ADDENDUM NO. 1

CSP# 207702

**Org # 194 – K.B. Polk Center for Academically Talented & Gifted -
Renovation**

20 December 2024

SHEET NUMBER
E10.02

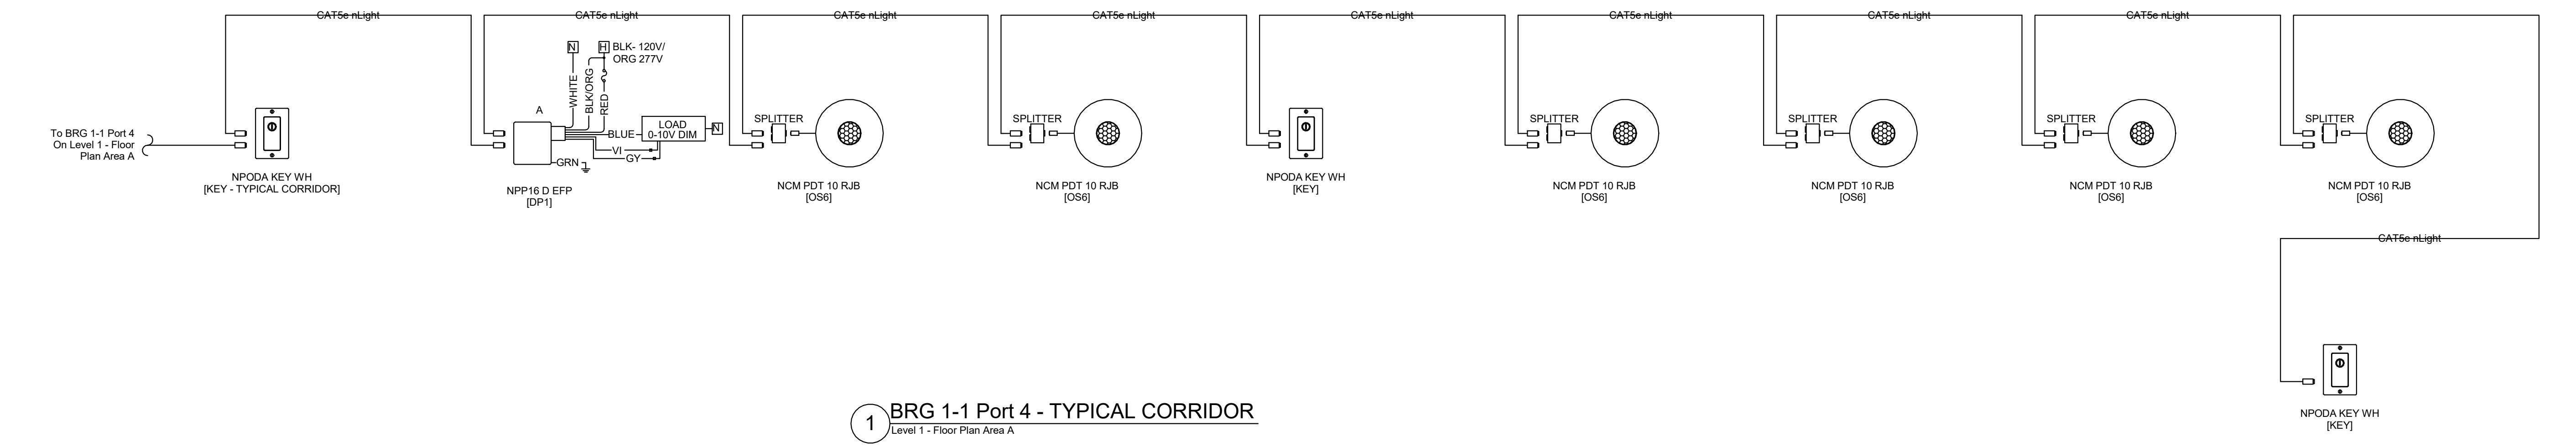
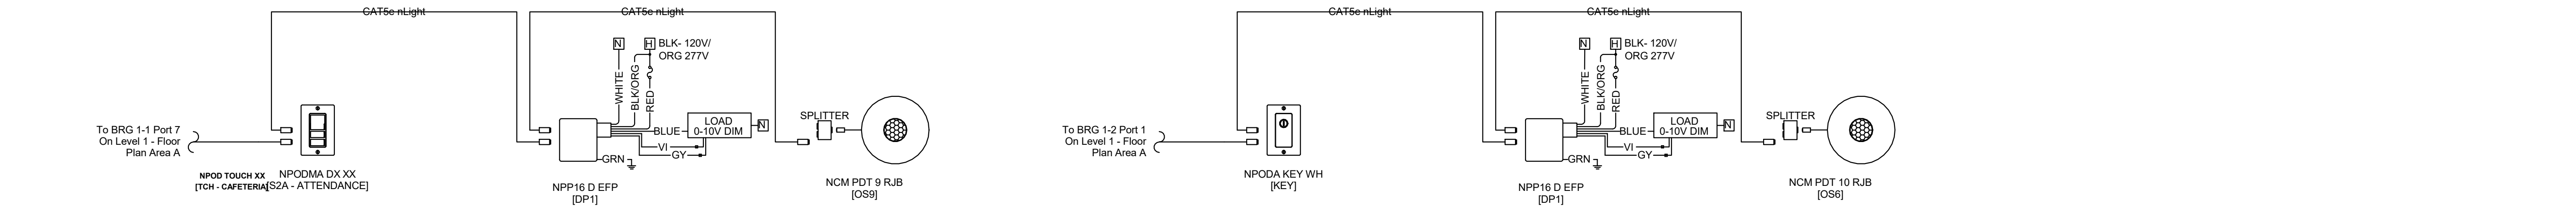
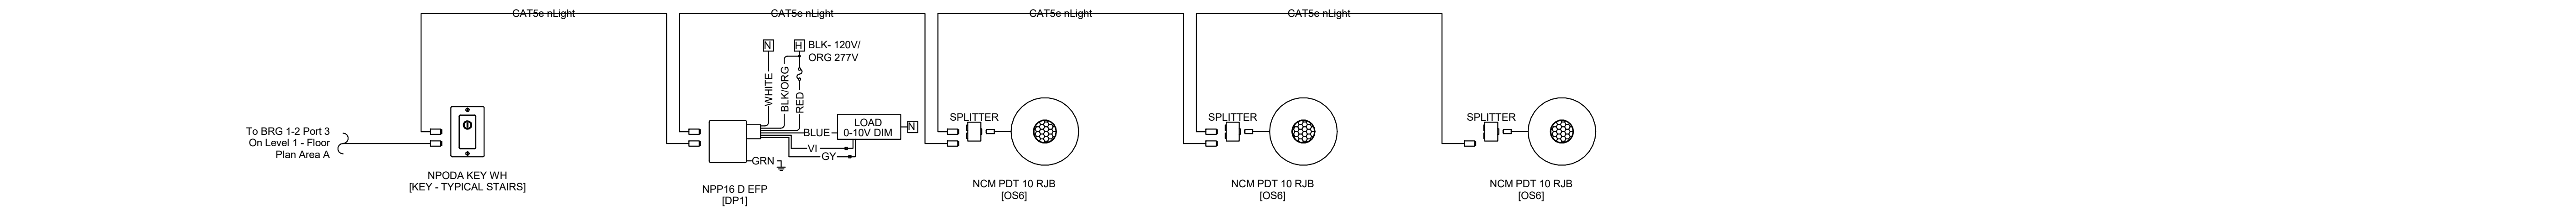
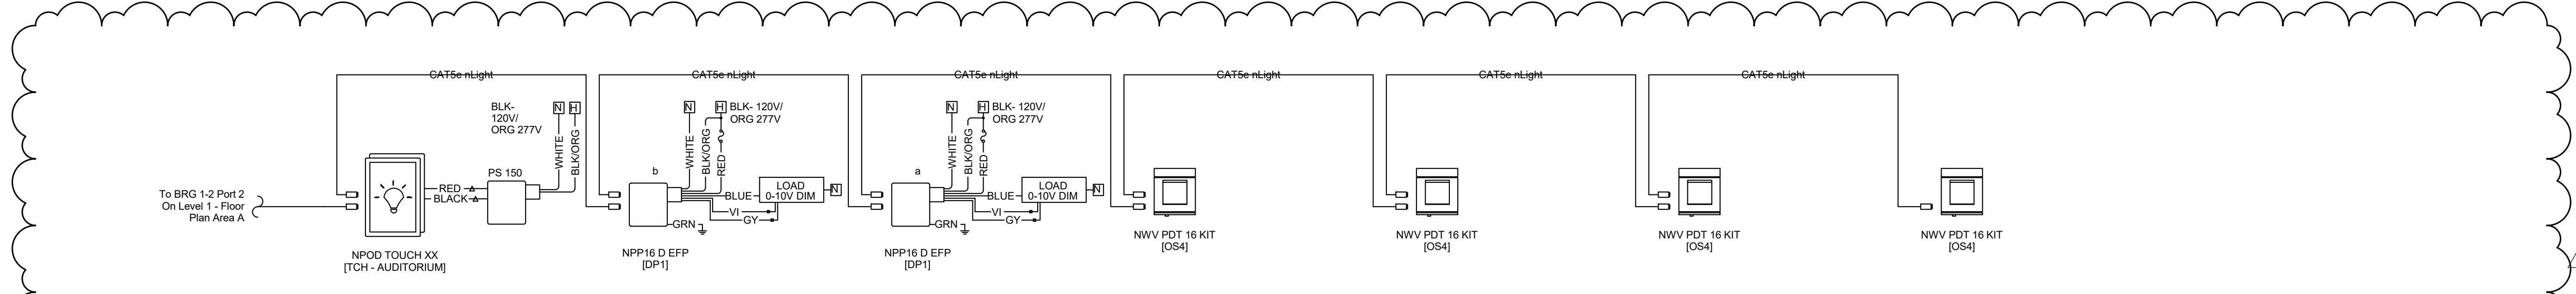
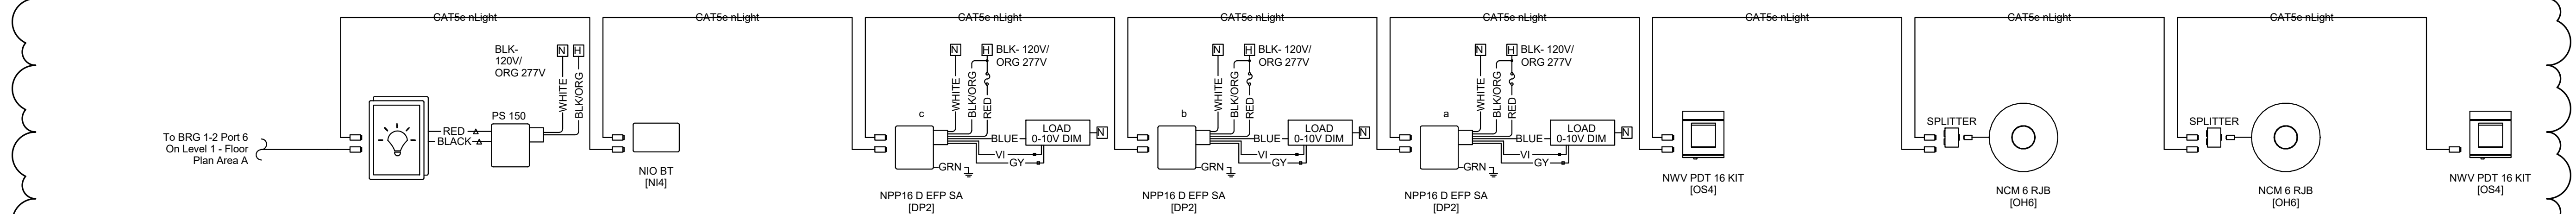
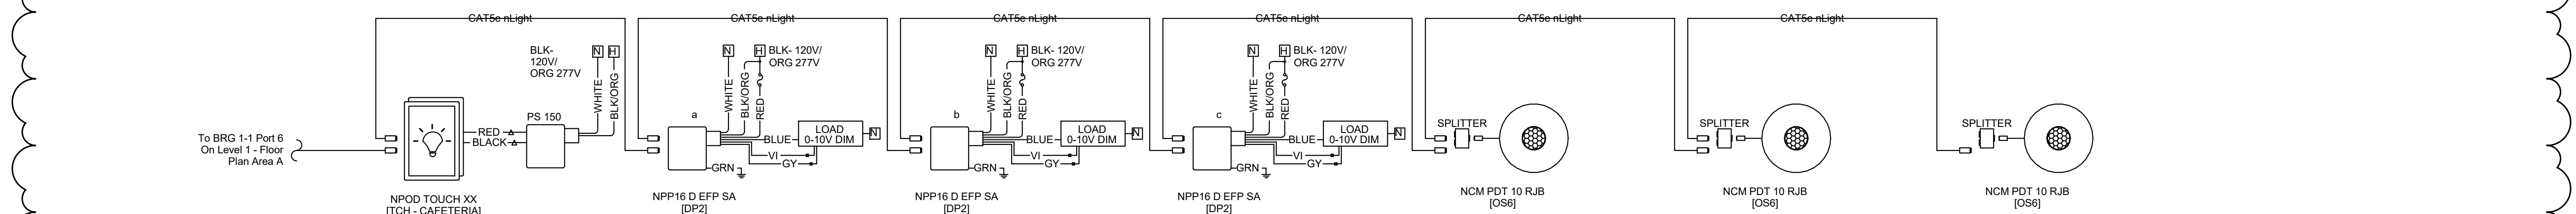
- **Sheet E6.05 - Replace sheet with the revised attached E6.05 LEVEL 2 LIGHTING CONTROLS PLAN B**
 - Revised sheet notes and scope per attached sheet.
- **Sheet E10.02 – Replace sheet with the revised attached E10.2 LIGHTING CONTROLS DETAILS**

- Revised sheet notes and scope per attached sheet.
